DrawDiff Comparison Report

Part number: P-001 | Job: 6cfcbeba-bc19-4ad3-a7cd-31ff4b6b13ed | Generated: 2026-05-05T04:10:31+00:00

ISO_LEFT_VIEW [MATCHED]

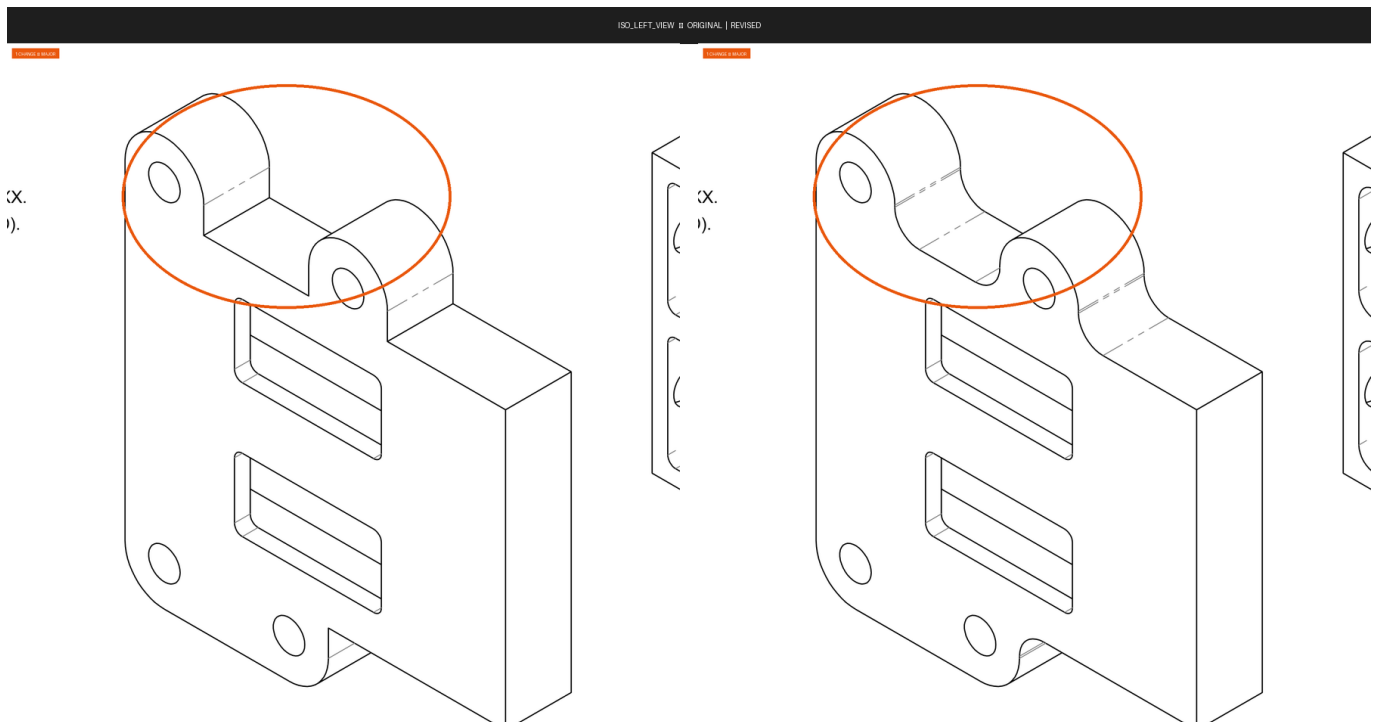
Severity	Field	Zone	Original	Revised	Conf.	Rationale
SIGNIFICANT	geometry	A4	Hinge knuckle/ barrel shown as cylindrical tube with flat top face and sharp shoulder transition	Hinge knuckle/ barrel shown with full rounded/ filleted profile and smooth curved transition along top — no flat top face or sharp shoulder	0.82	The top hinge barrel profile changed from a flat-topped cylindrical knuckle with a distinct shoulder step to a fully rounded knuckle with a smooth continuous fillet transition, indicating a geometric/feature change that affects the physical shape of the hinge barrel and its interface with mating parts.

ISO_RIGHT_VIEW [MATCHED]

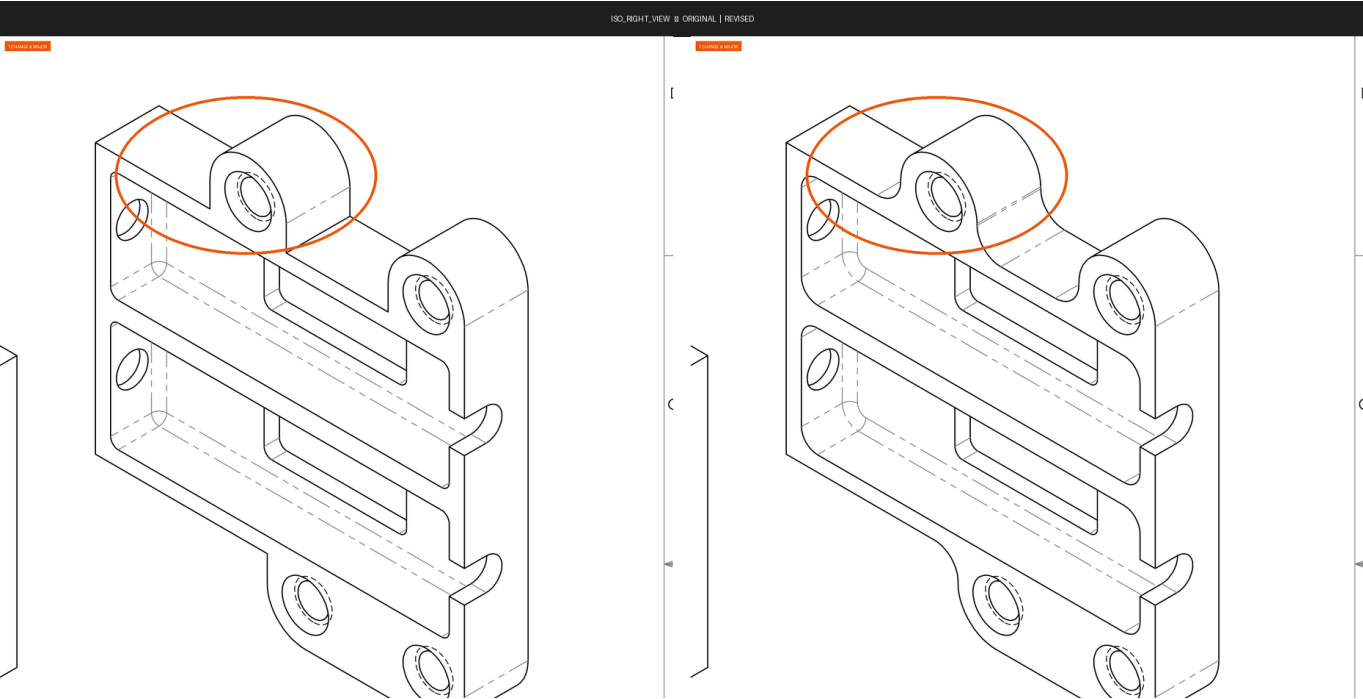
Severity	Field	Zone	Original	Revised	Conf.	Rationale
SIGNIFICANT	geometry	A2	Top front edge of upper block has a flat/ square profile with a visible step or ledge at the top-left corner of the upper boss area	Top front edge of upper block shows a chamfer or fillet blending the top-left corner of the upper boss area into the main body — the sharp step/ ledge is replaced by a curved/ angled transition	0.72	The upper-left region of the top block shows a geometric profile change between revisions: the original has a more prominent flat ledge/step at the top front corner near the cylindrical boss, while the revised version shows a smoother chamfered or filleted blend, indicating a functional geometry modification that affects the part envelope and potentially its mating or structural behavior.

SECTION B-B [MATCHED]

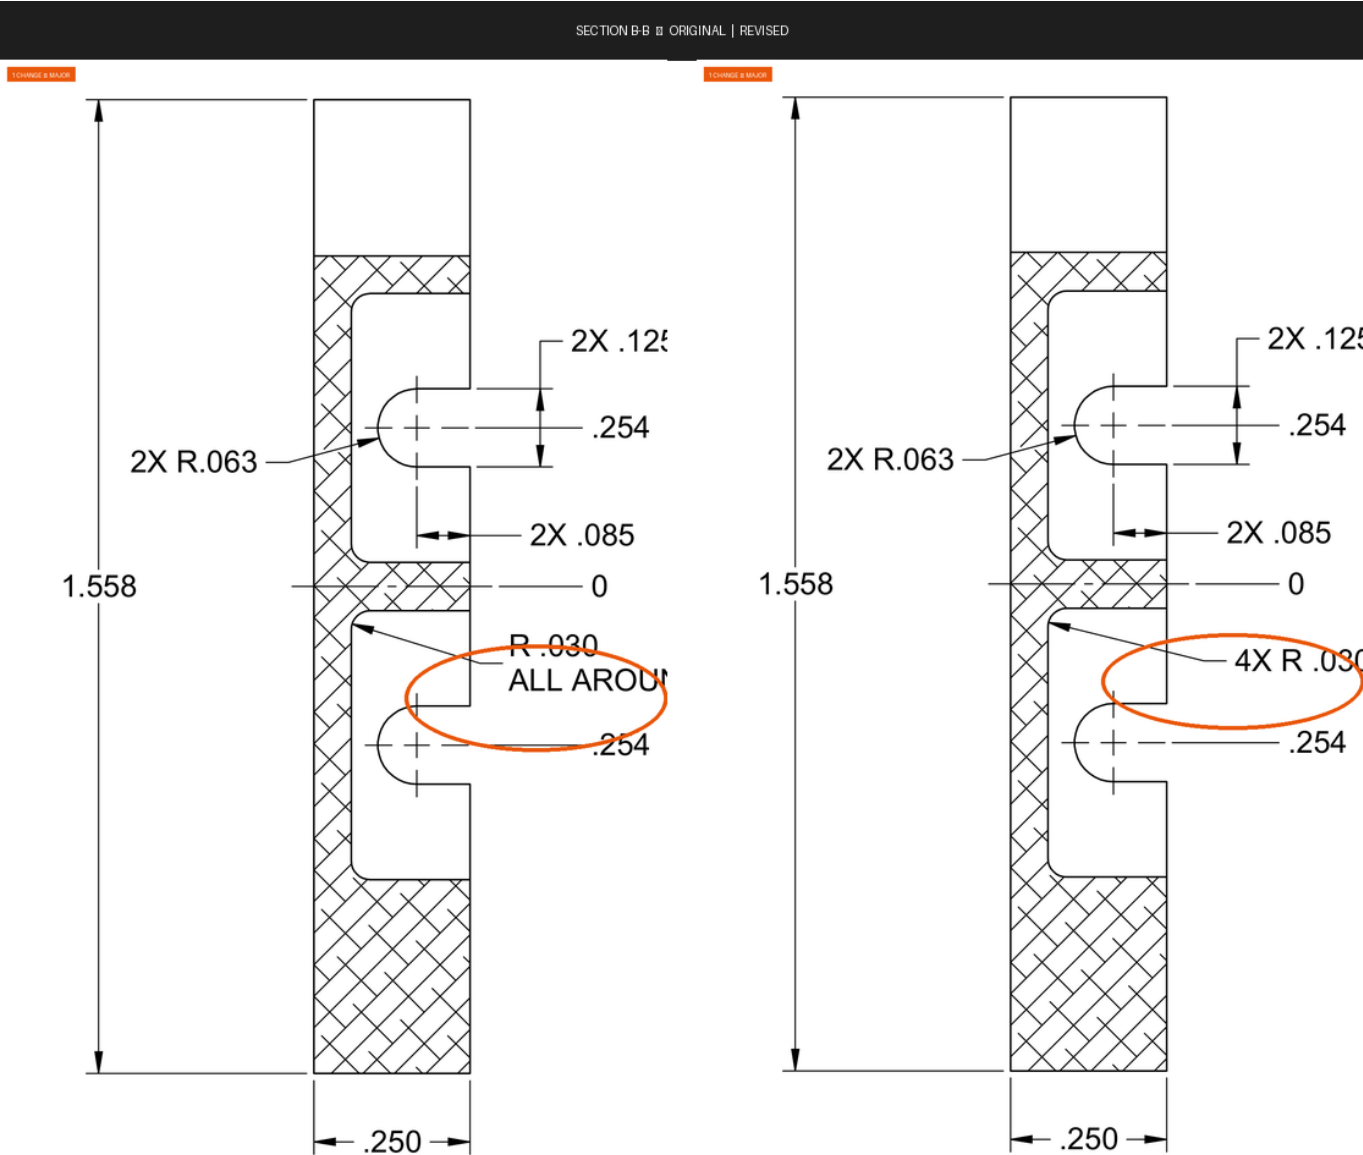
Severity	Field	Zone	Original	Revised	Conf.	Rationale
SIGNIFICANT	callout	B7	R .030 ALL AROUND	4X R .030	0.92	The radius callout changed from 'R .030 ALL AROUND' to '4X R .030', replacing the all-around specification with an explicit count of 4 instances, which changes the scope and intent of where the radius applies.

FRONT_VIEW [MATCHED]

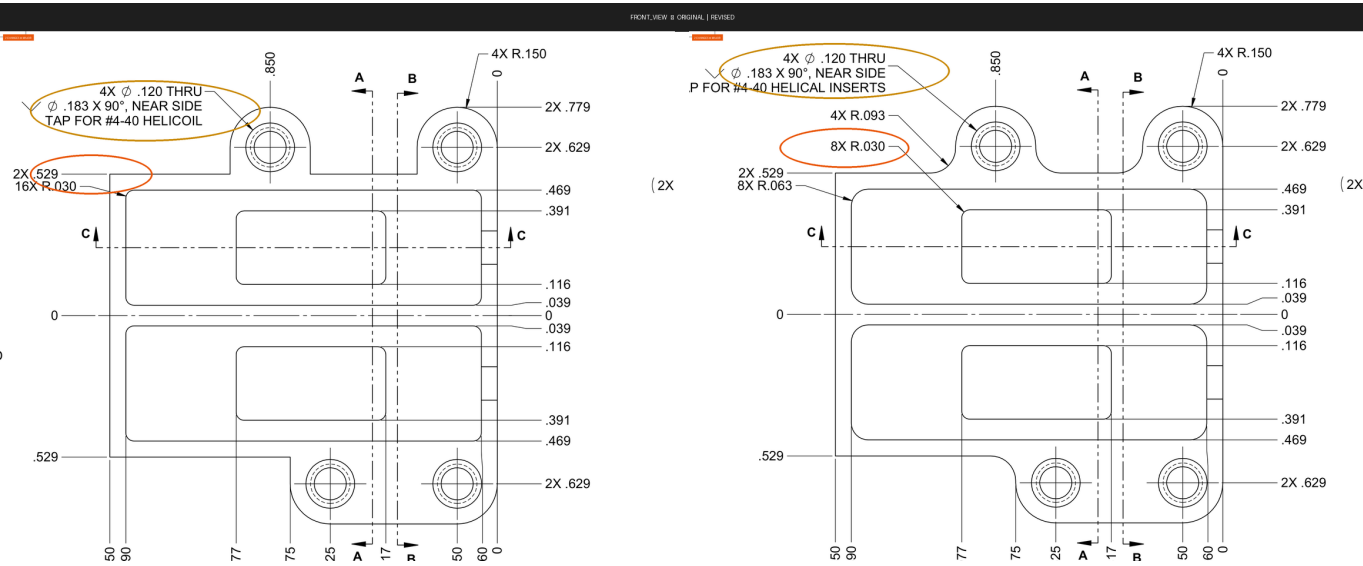
Severity	Field	Zone	Original	Revised	Conf.	Rationale
SIGNIFICANT	dimension	A5	16X R.030	8X R.030	0.90	The quantity of R.030 radius features on the main body was reduced from 16 to 8, indicating a change in the number of corner radii of this size applied to the part.
MINOR	note	A6	TAP FOR #4-40 HELICOIL	TAP FOR #4-40 HELICAL INSERTS	0.92	The thread insert brand name 'HELICOIL' was replaced with the generic term 'HELICAL INSERTS', which is a documentation/terminology change but does not alter the functional specification.

SECTION A-A [MATCHED]

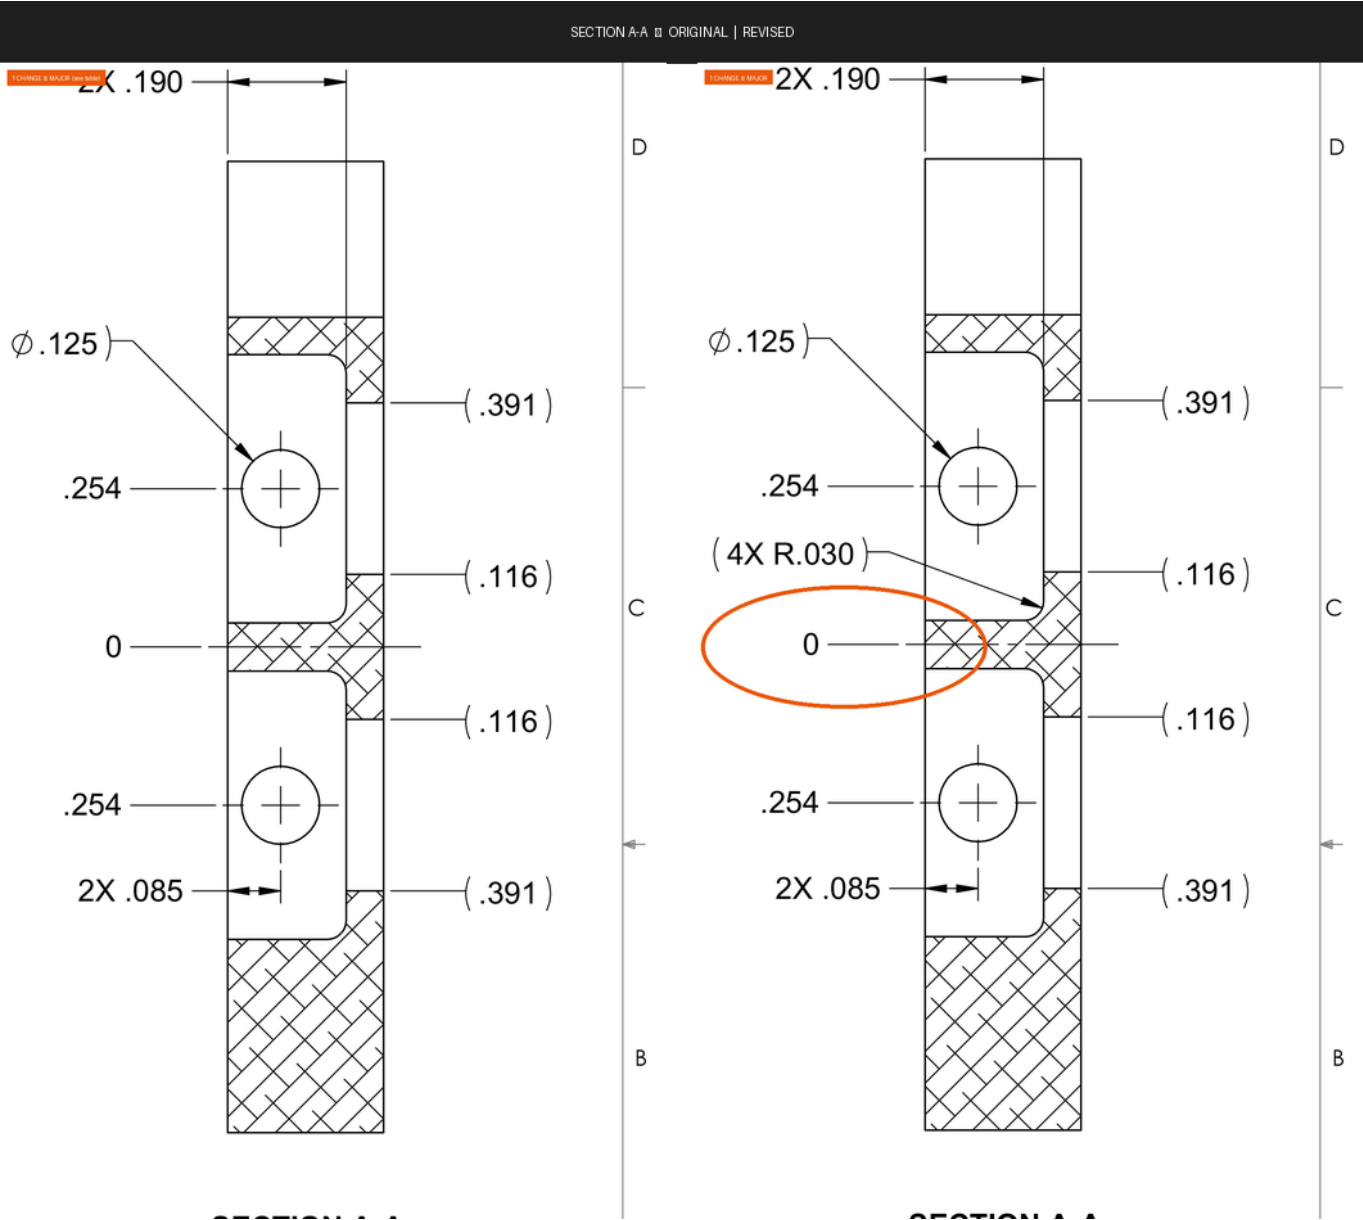
Severity	Field	Zone	Original	Revised	Conf.	Rationale
SIGNIFICANT	annotation	B2	—	(4X R.030)	0.92	A new reference callout '(4X R.030)' has been added in the revised drawing, indicating four corner radii of 0.030 on the slot/pocket feature, which is a new manufacturing requirement not present in the original.

SECTION C-C [MATCHED]

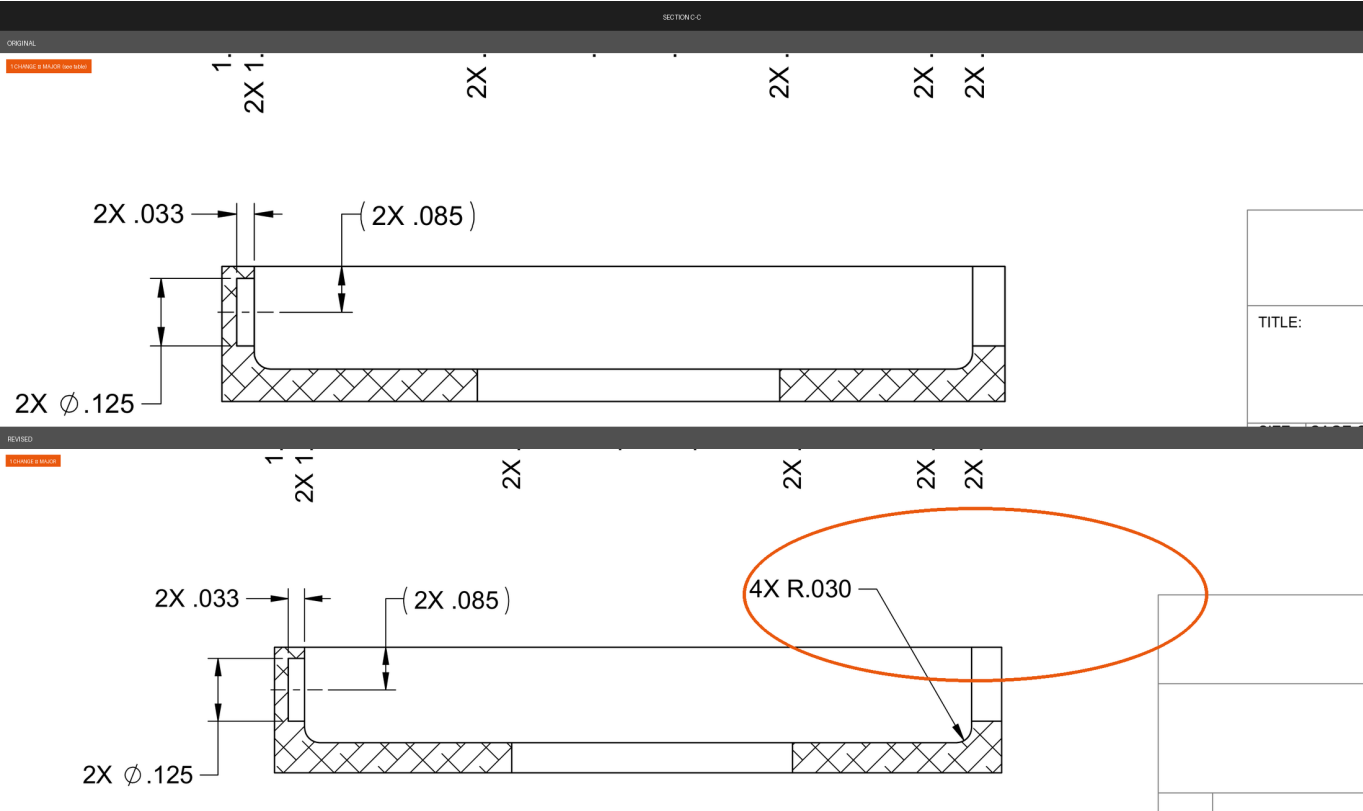
Severity	Field	Zone	Original	Revised	Conf.	Rationale
SIGNIFICANT	callout	D3	—	4X R.030	0.92	A new radius callout '4X R.030' with leader pointing to the inner corner of the channel has been added in the revised drawing, specifying four corner radii that were not previously called out, which affects machining and fit requirements.
